AF88.70-P-1100AG	Wind noise at outside mirror on left and/or right front door	30.10.03	Ì
------------------	--	----------	---

MODEL 163.154 #A as of 289560, 163.113 /128 #X as of 754620, 163.113 /174 #A as of 289560 up to 486952, 163.128 /157 /175 #A up to 486952

P88.70-2311-11

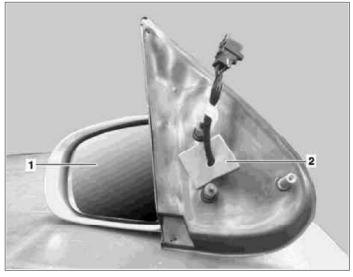
Damage Code	Cause	Remedy	
81 101 39	Insufficient seal pressure between door and	1 Remove outside rearview mirror (1) only on side where wind noise occurs.	AR88.70-P-9000GH
	base of mirror mount.	on side where wind noise occurs.	*110589035900
		2 Install foam (2) onto base of mirror mount around wiring harness.	
		3 Reinstall outside rearview mirror (1).	AR88.70-P-9000GH
		i Replace foam on inside of door around hole where mirror wiring harness comes through.
